Reference: C.N.37.2001.TREATIES-2 (Depositary Notification)

CUSTOMS CONVENTION ON THE INTERNATIONAL TRANSPORT OF
GOODS UNDER COVER OF TIR CARNETS (TIR CONVENTION)

PROPOSAL OF AMENDMENTS TO ARTICLE 3 AND
TO ANNEXES 2 AND 7 OF THE CONVENTION

OTHER AMENDMENT PROPOSALS TO THE TIR CONVENTION, 1975
Adopted by the TIR Administrative Committee on 20 October 2000

EXAMPLE OF A CONSTRUCTION OF A CONTAINER WITH SLIDING SHEETS

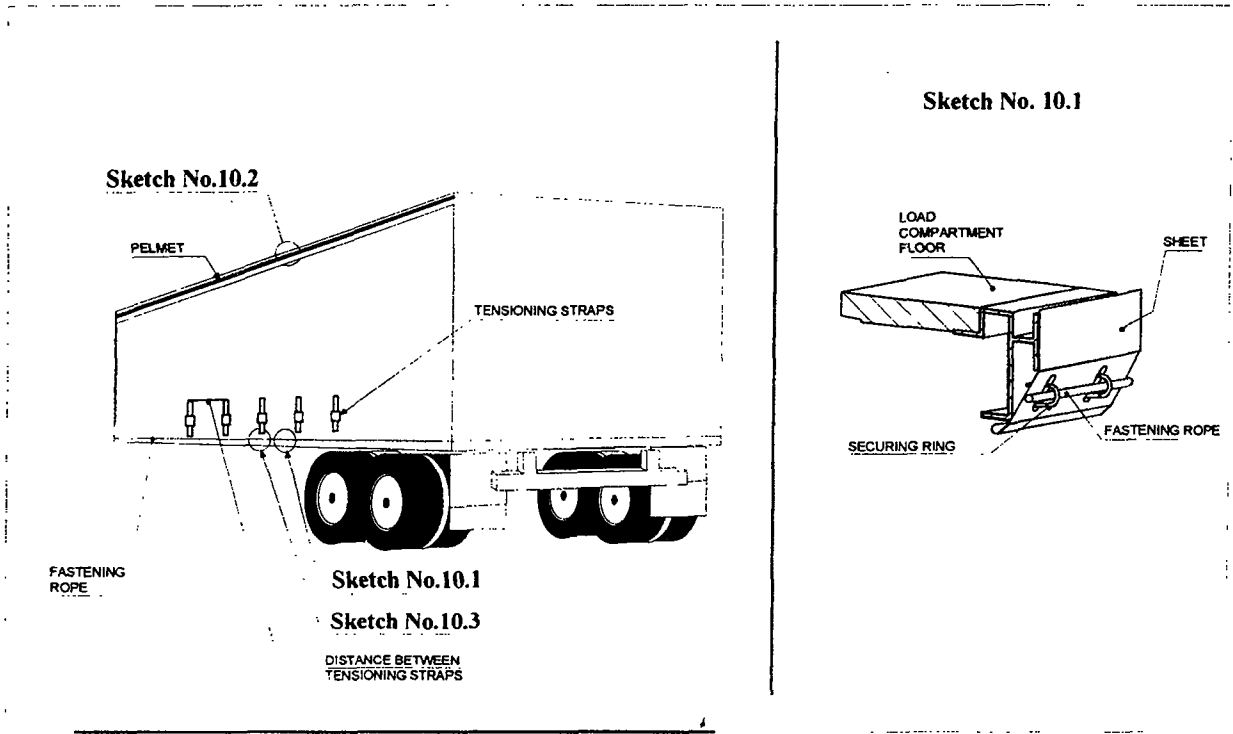
Replace the text of Article 5 by the following:

“Article 5Containers with sliding sheets

1. Where applicable, the provisions of Articles 1, 2, 3 and 4 of these Regulations shall apply to containers with sliding sheets. In addition, these containers shall conform to the provisions of this article.

2. Notwithstanding the provisions of paragraph 3 of this Article, the sliding sheets, floor, doors and all other constituent parts of the container shall fulfil either the requirements in Article 4, paragraphs 6, 8, 9 and 11 of these Regulations or the requirements set out in (i) to (vi) below.

- (i) The sliding sheets, floor, doors and all other constituent parts of the container shall be assembled in such a way that they cannot be opened or closed without leaving obvious traces.

- (ii) The sheet shall overlap the solid parts at the top of the container by at least 1/4 of the actual distance between the tensioning straps. The sheet shall overlap the solid parts at the bottom of the container by at least 50 mm. The horizontal opening between the sheet and the solid parts of the container may not exceed 10 mm measured perpendicular to the longitudinal axis of the container at any place when the container is secured and sealed for Customs purposes.

- (iii) The sliding sheet guidance and other movable parts shall be assembled in such a way that closed and Customs sealed doors and other movable parts cannot be opened or closed from the outside without leaving obvious traces. The sliding sheet guidance and other movable parts shall be assembled in such a way that it is impossible to gain access to the container without leaving obvious traces. The system is described in sketch No. 10 appended to these Regulations.

- (iv) The horizontal distance between the rings, used for Customs purposes, on the solid parts of the container shall not exceed 200 mm. The space may, however, be greater but shall not exceed 300 mm between the rings on either side of the upright if the construction of the container and the sheets is such as preventing all access to the container. In any case, the conditions laid down in (ii) above shall be complied with.
- (v) The distance between the tensioning straps shall not exceed 600 mm.
- (vi) The fastenings used to secure the sheets to the solid parts of the container shall fulfil the requirements in Article 4, paragraph 9 of these Regulations.”
